**RE: Gas Hills, Wyoming License Number SUA-648, Docket #40-0299  
ACL Application**

Enclosed please find the revised *Groundwater Monitoring Plan*, Appendix M of Umetco's ACL Application. The NRC staff has expressed a concern that the plume in the southwest flow regime would skirt MW74. Accordingly, Umetco proposes to delete MW74 from the monitoring plan and construct a new well, MW82, which is appropriately located to monitor the southwest flow regime.

## **Appendix M**

# **Groundwater Monitoring Plan Gas Hills, Wyoming**

FIGURE M-1

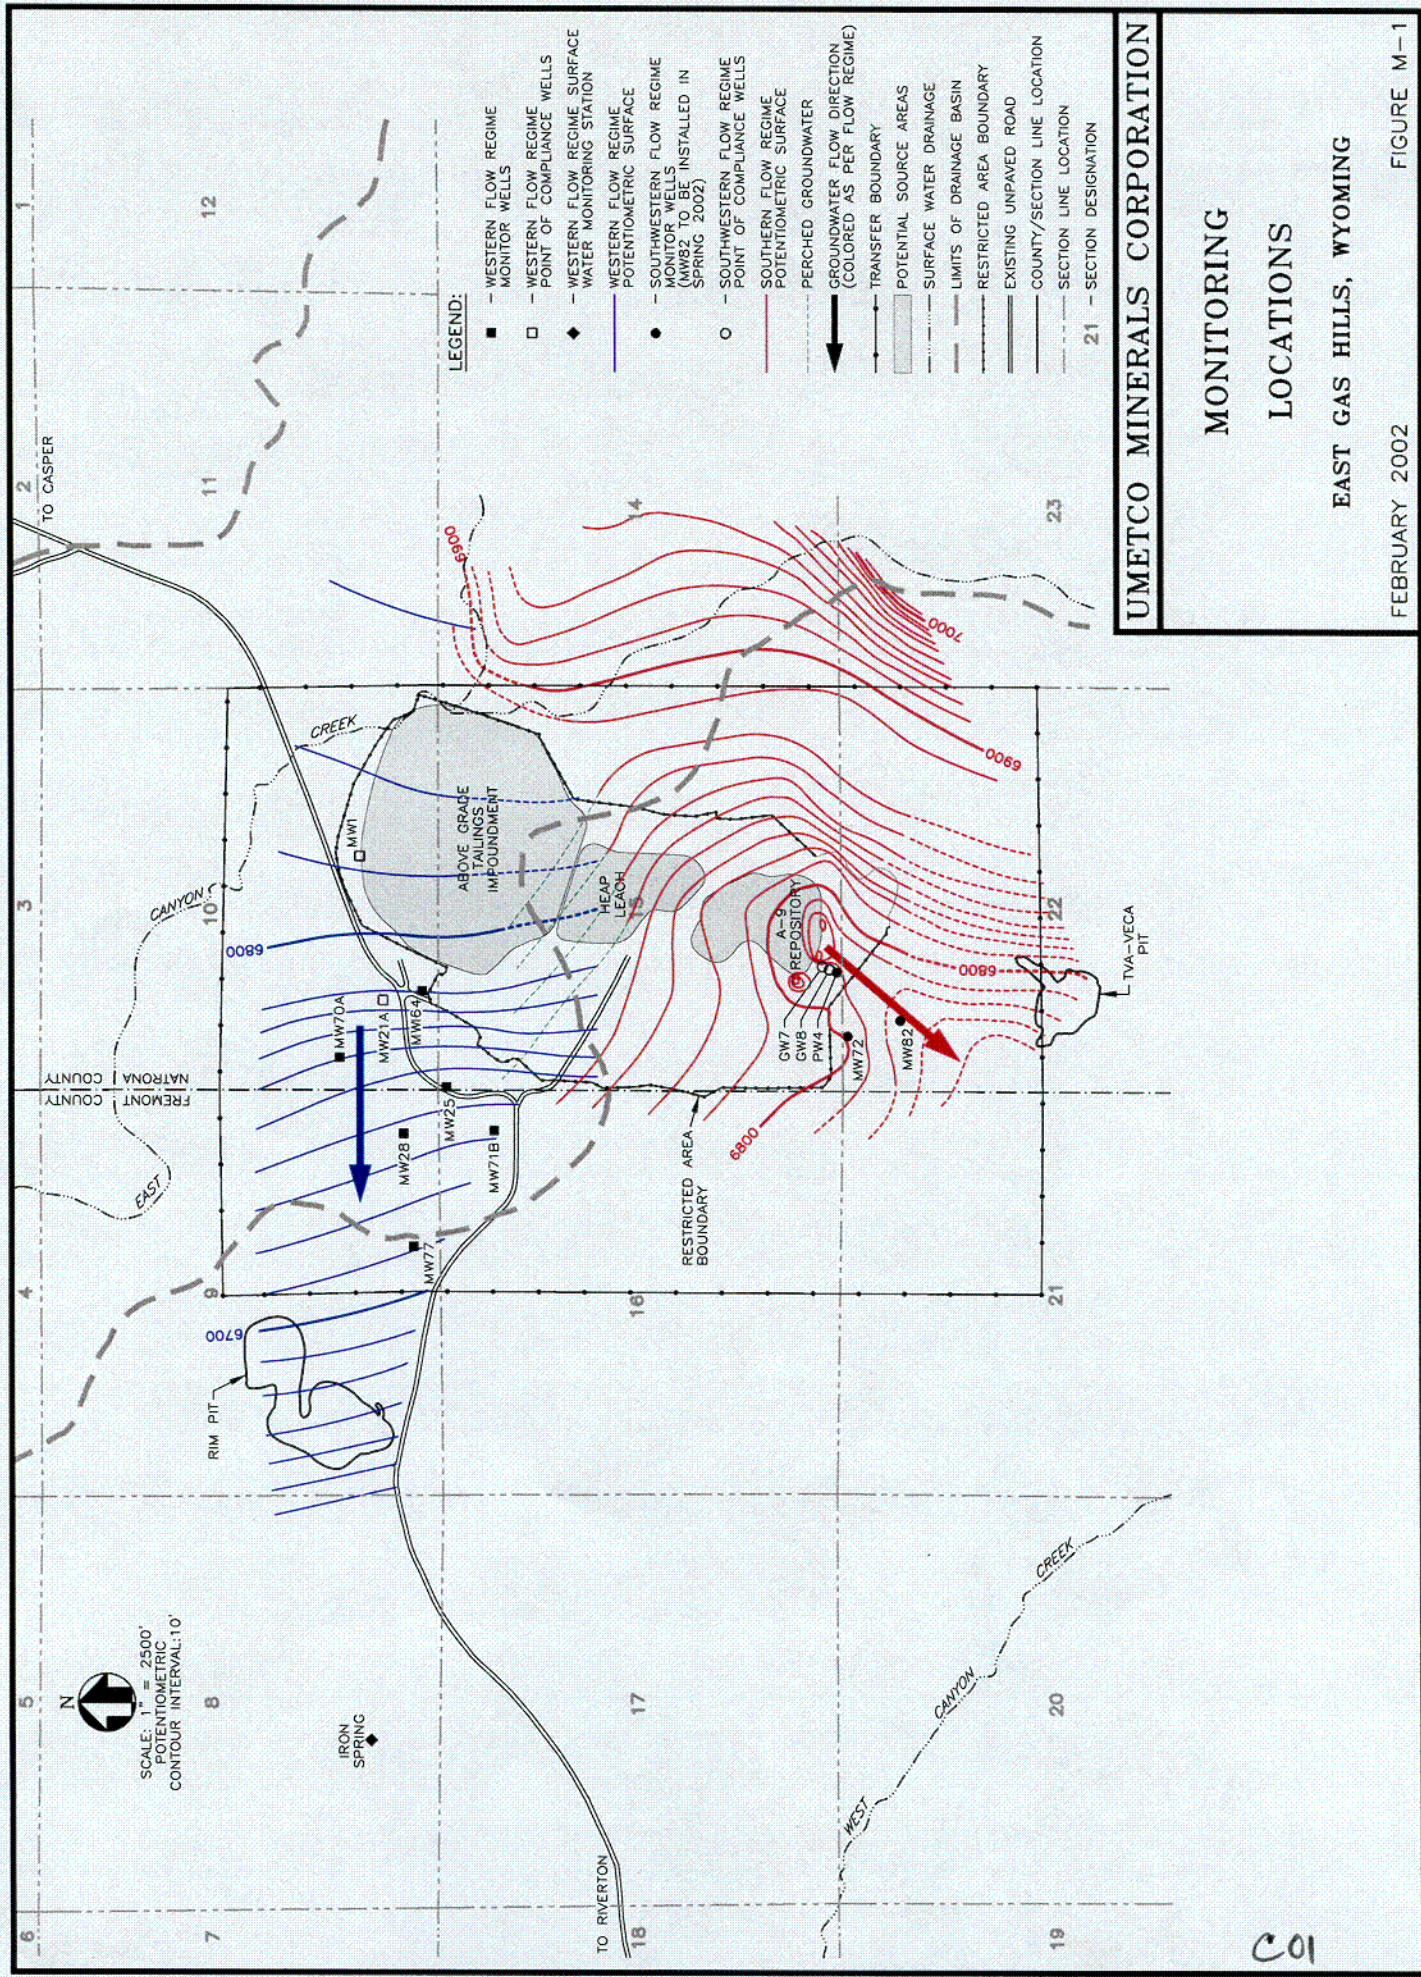
MW82 will be completed within the Upper Wind River aquifer (above the mudstone unit that separates the Upper and Lower Wind River aquifers), near existing well MW30 (a Lower Wind River aquifer completion). Approximate coordinates of MW82 are N 788300 and E 835800. This location was selected because it is downgradient of the A-9 Repository and along the flowpath of groundwater migrating from that impoundment. The location is also hydraulically upgradient of the Power Resources, Inc. (PRI) proposed Mine Unit No. 5 and the underground Thunderbird and ROX mines. The elevation of the water table beneath the proposed well location is projected to be at 6790. Ground surface elevation is approximately 6840. Depth to water will be approximately 50 feet. The well will be constructed similar to previous monitoring wells MW72 and MW74 and will be screened across the upper 15-20 feet of the Upper Wind River aquifer. MW30 already provides sufficient monitoring at that location for the deeper hydrologic flow system within the Lower Wind River.

The revised *Groundwater Monitoring Plan* provides the location for the new monitor well and predicted trends used to establish action limits.
